**LEGAL ADVERTISEMENT
PORTLAND PLANNING BOARD MEETING**

To: Elizabeth Boepple, Chair, and Members of the Portland Planning Board
From: Shukria Wiar, Planner
Date: January 13, 2017
Re: 161 York Street
Project #: 2016-261 **CBL:** 044 B 006
Meeting Date: January 17, 2017

York Street Development LLC has requested a preliminary Level III site plan and subdivision review of an eleven-unit urban infill development at 161 York Street near the Casco Bay Bridge and State Street. The proposed 11,046 SF development includes a five-story multifamily building with parking at two different levels, as well as surface parking spaces. The site will be accessed from York Street and Guilford Court. The vacant lot was previously occupied by two 2-story residential buildings that have recently been demolished. The site is within the R-6 zone and within 100 feet of the West End Historic District.

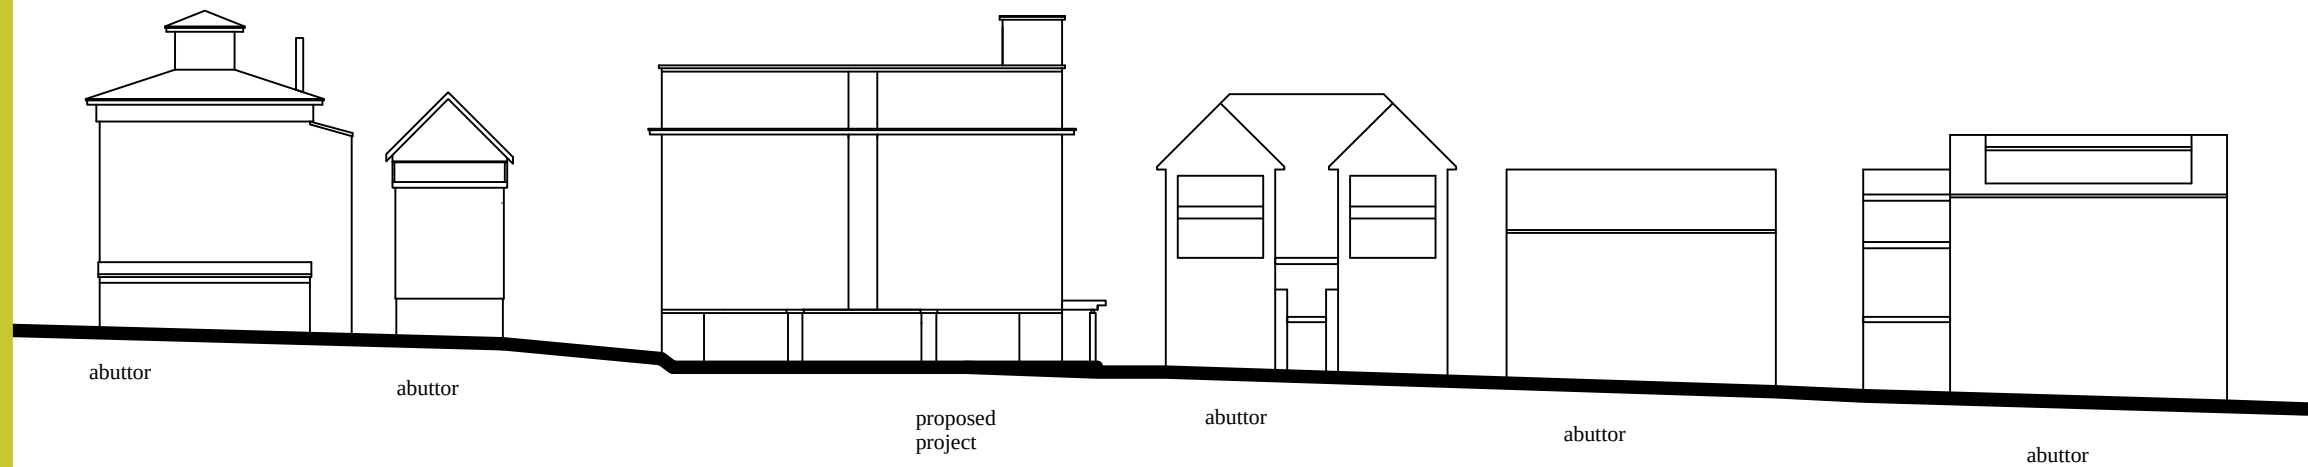
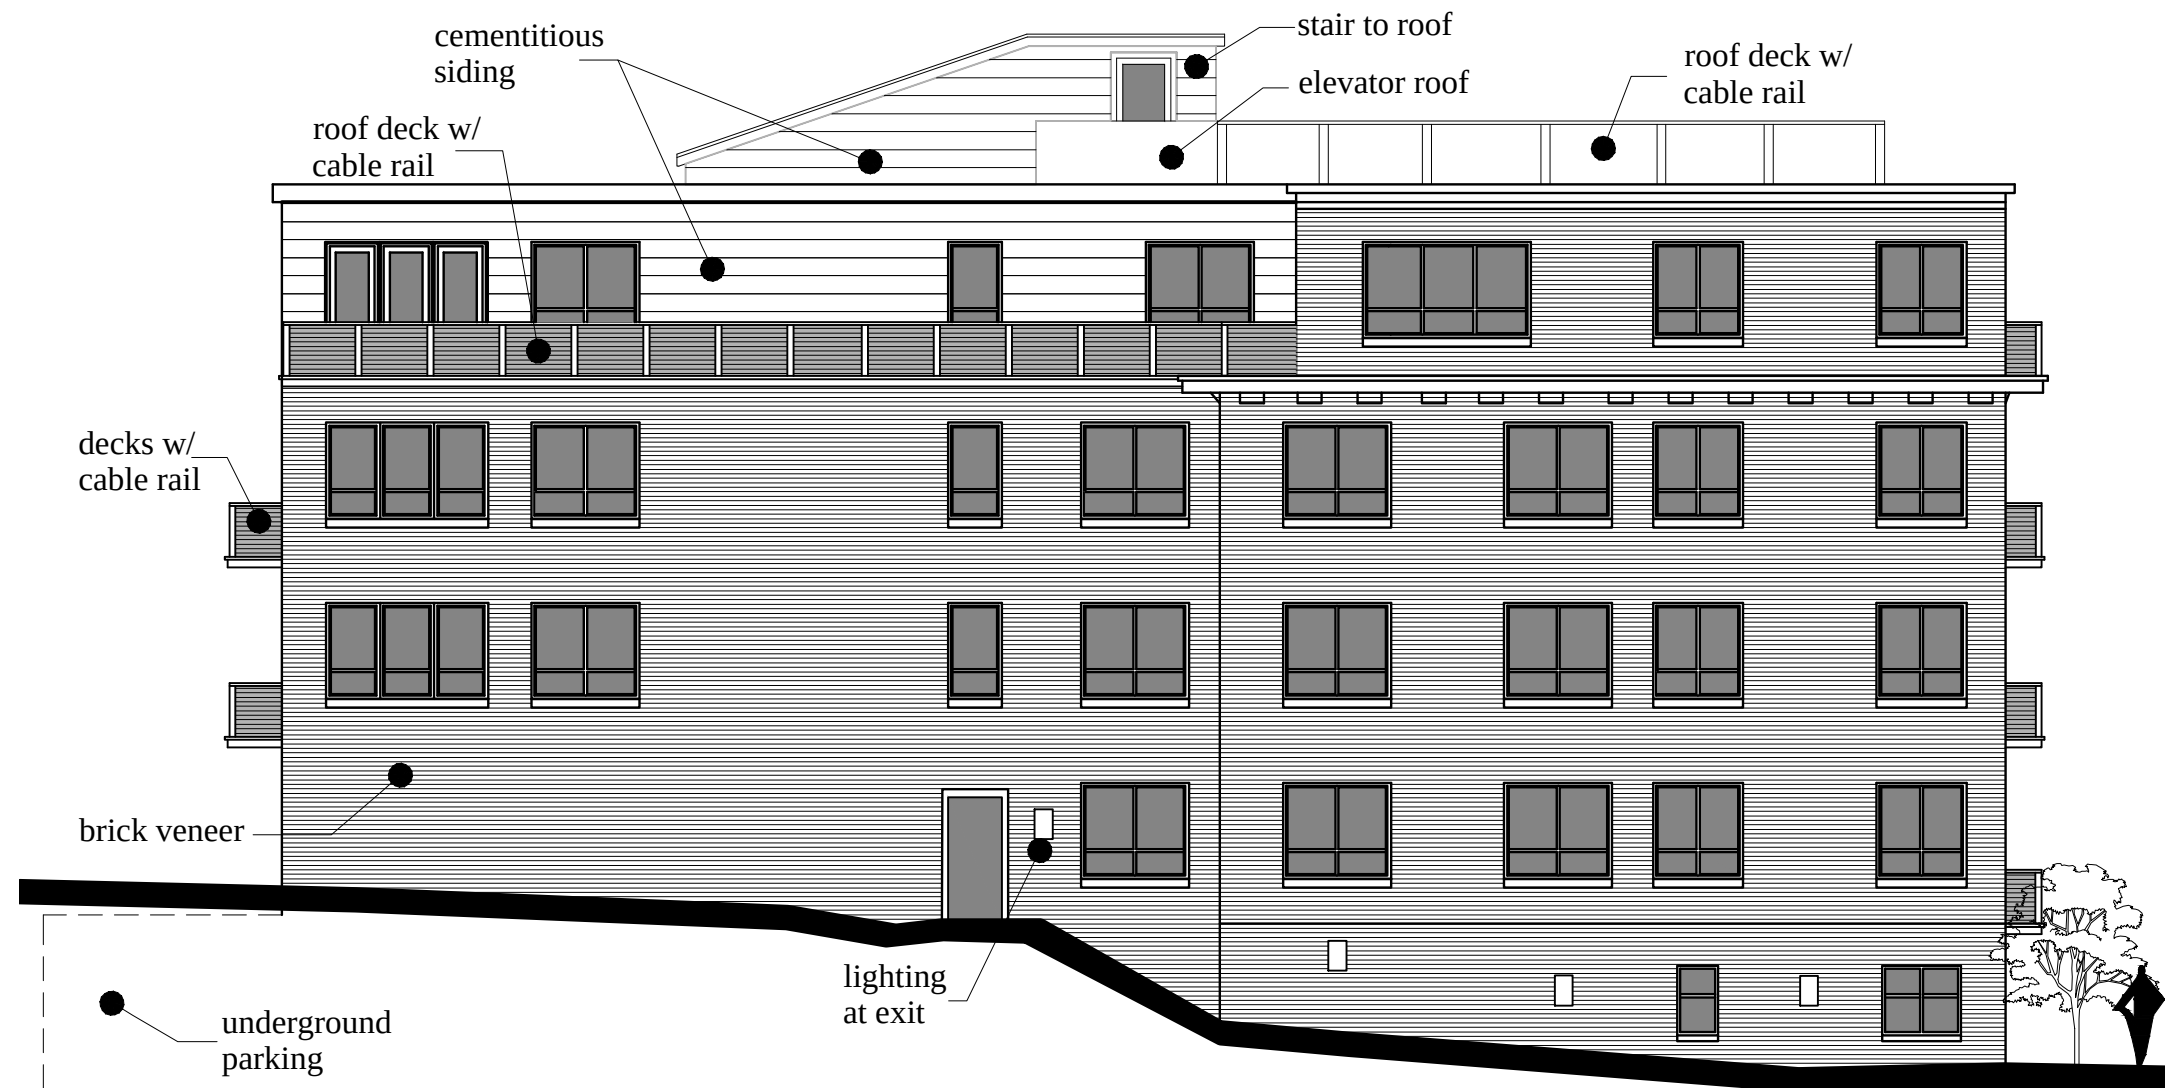
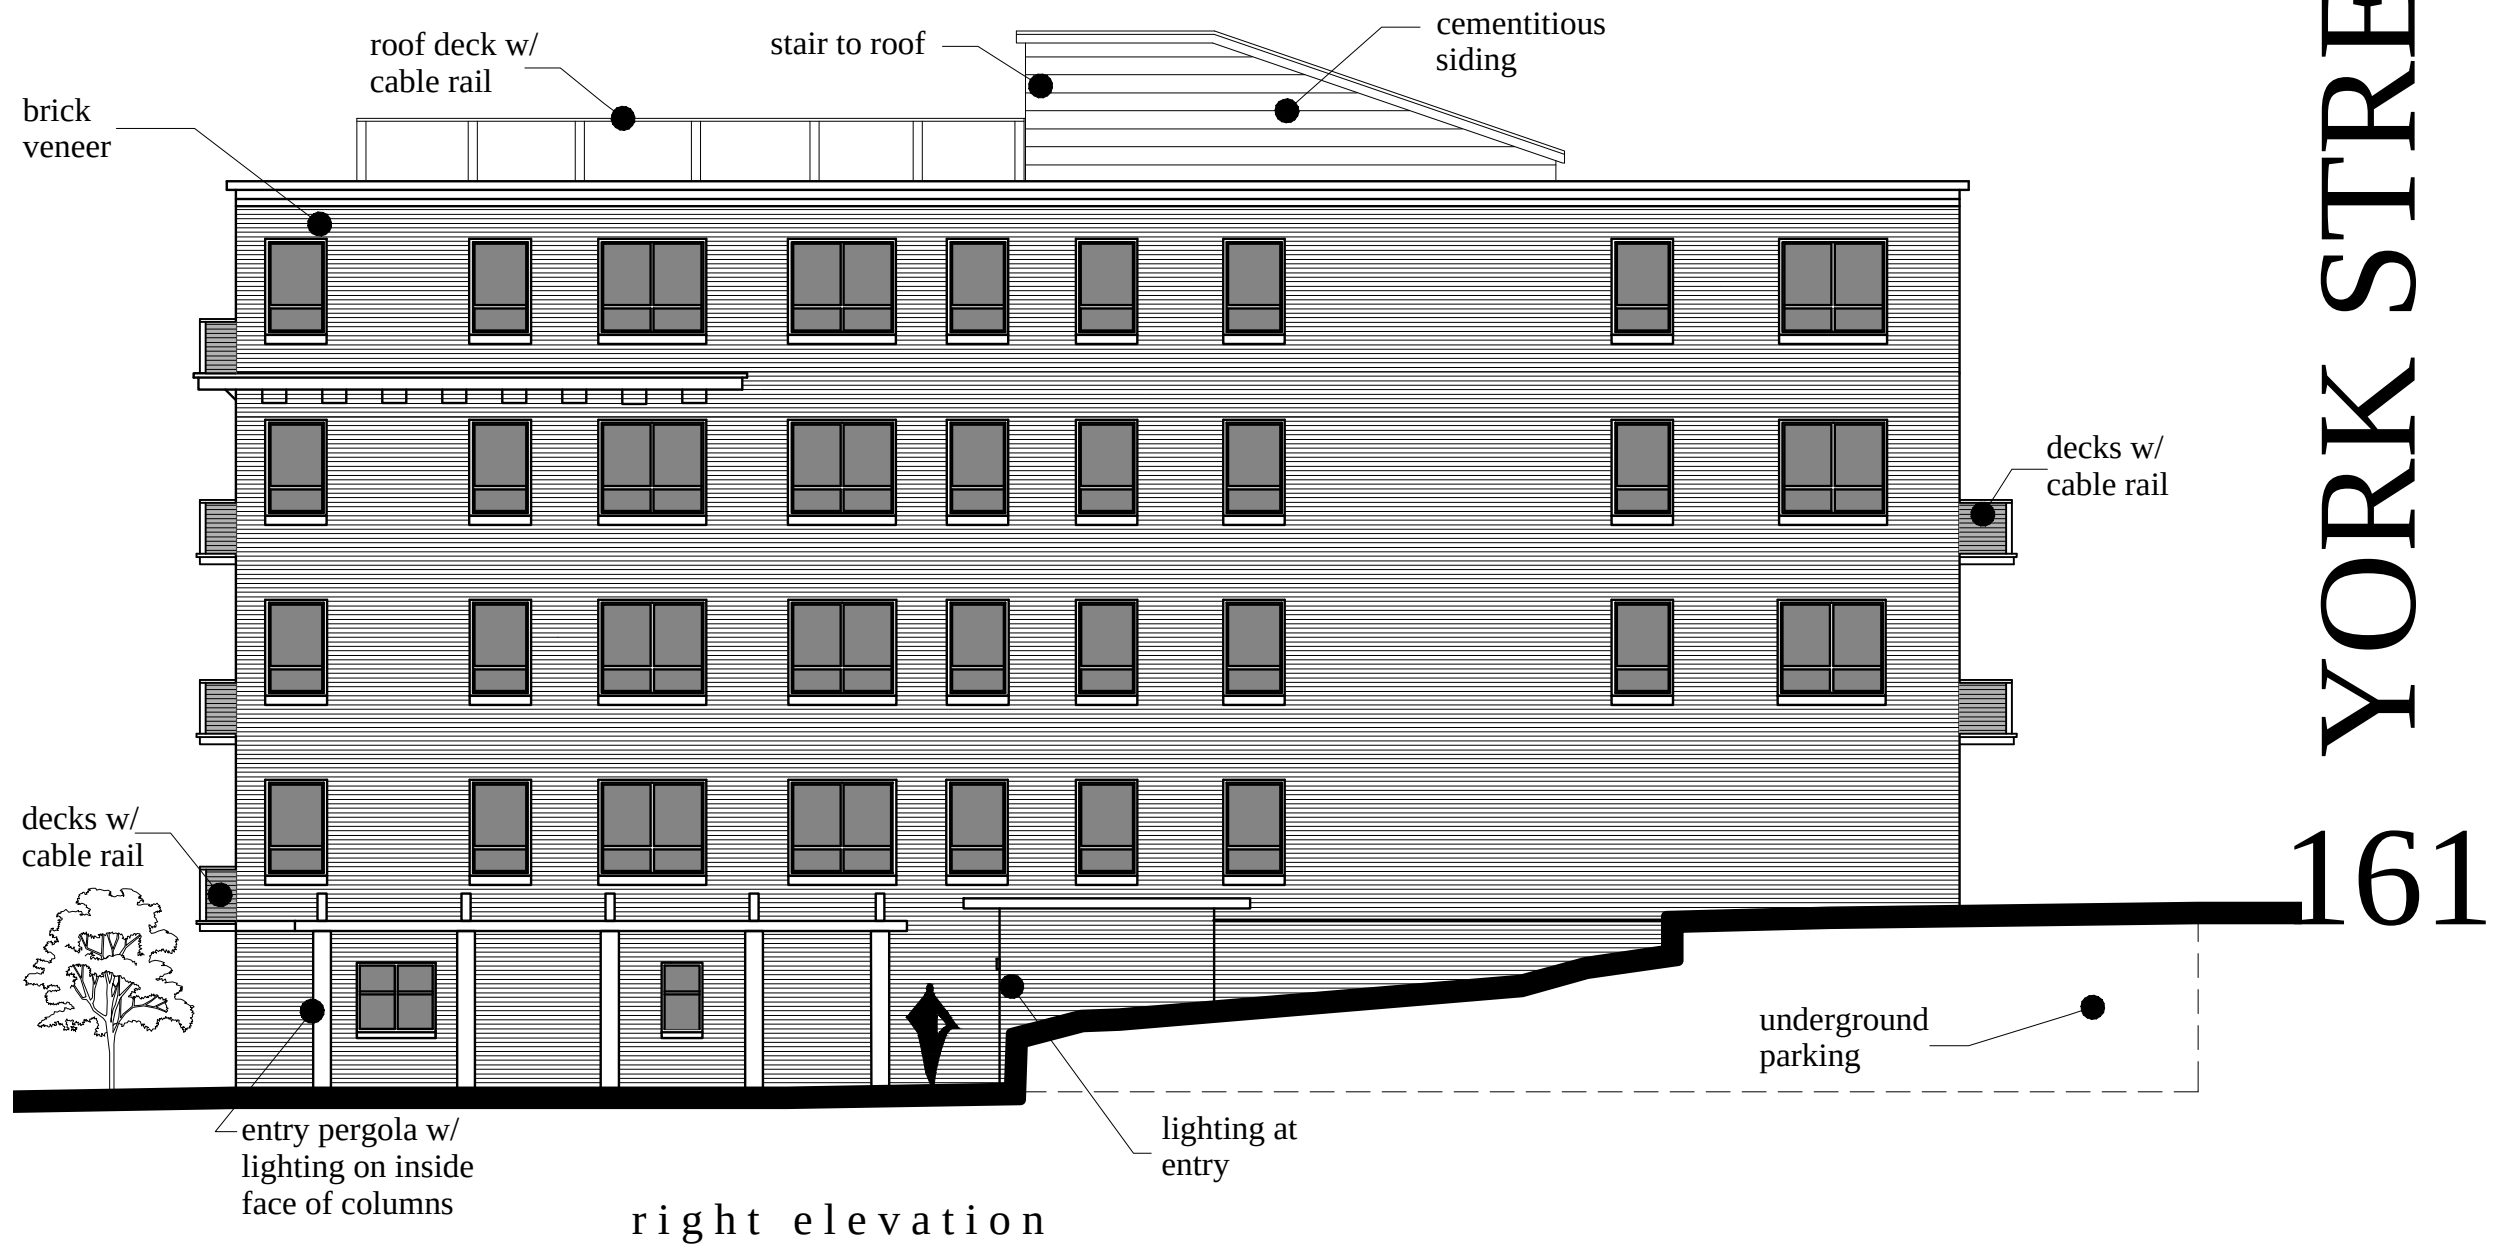
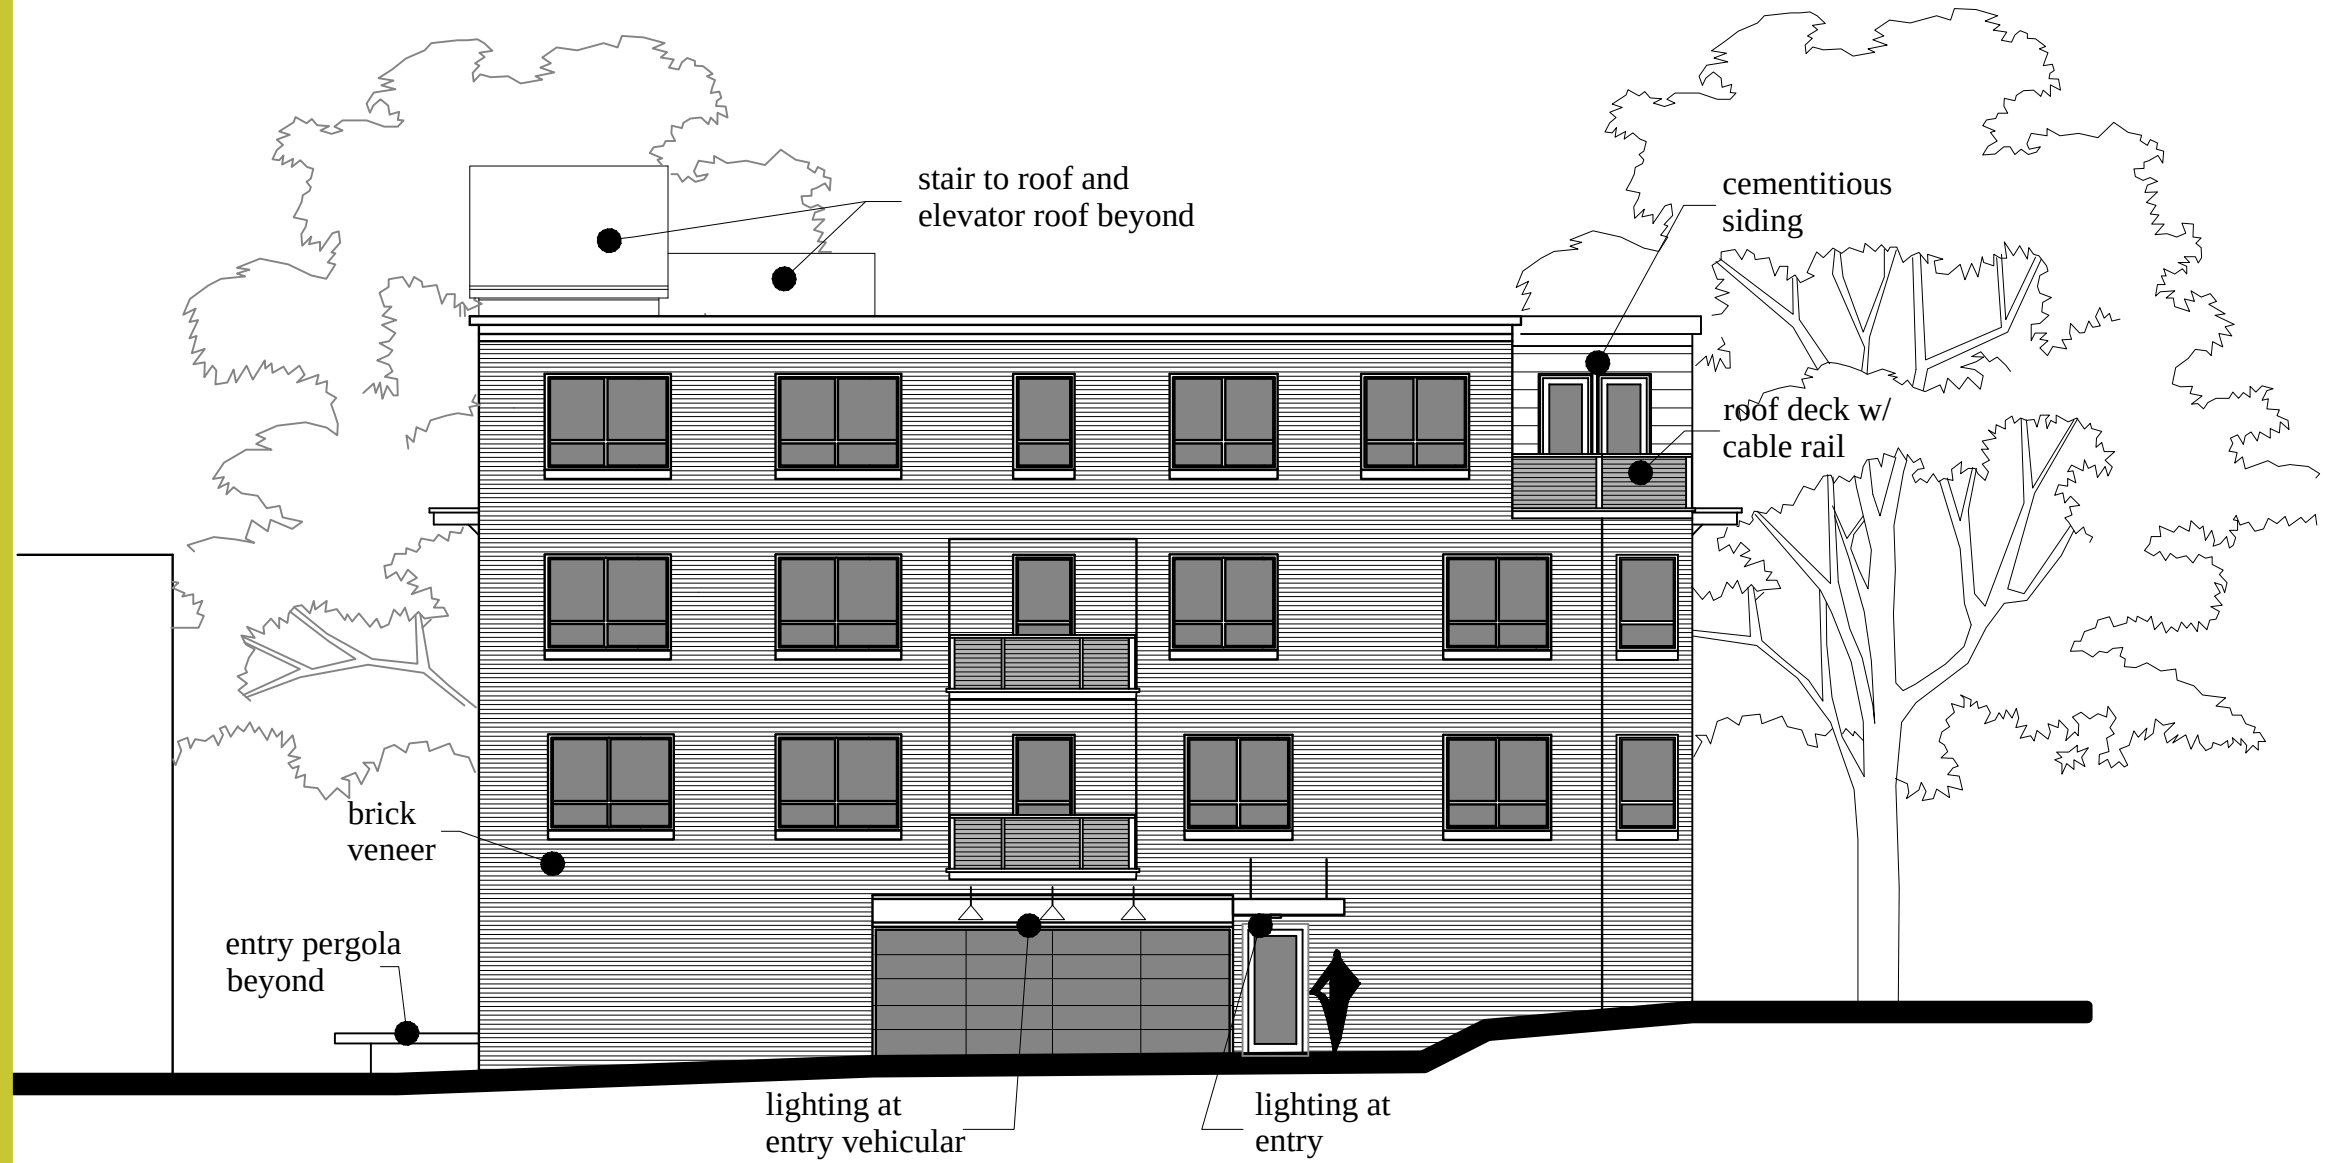
Staff Comments- *The project employs only one of the articulation elements required – covered entry. The balconies are too small to meet the required sf. Staff recommends that the design be modified to provide a more pronounced recess or projection where the balconies are currently located. Refer to 62 State Street as an example.*

Staff Comments- *Remove the “dentals” shown at the 4th floor cornice. More information is needed about the window reveals.*

- *F-2 Window Types*
Staff Comments- *Three window types at street façade. The ground floor windows imply living spaces – revise to reflect garage (smaller, higher windows, or use of grates).*
- *F-6 Main Entries*
Staff Comments- *The main entry is requires more emphasis.*
- *F-7 Articulation Elements: A cornice is provided at the fourth floor and appear to be at least 6”;* *no other façade offsets are provided.*
Staff Comments- *To meet standard B-5, either recesses or bay projections of at least 12” are required on the front façade.*
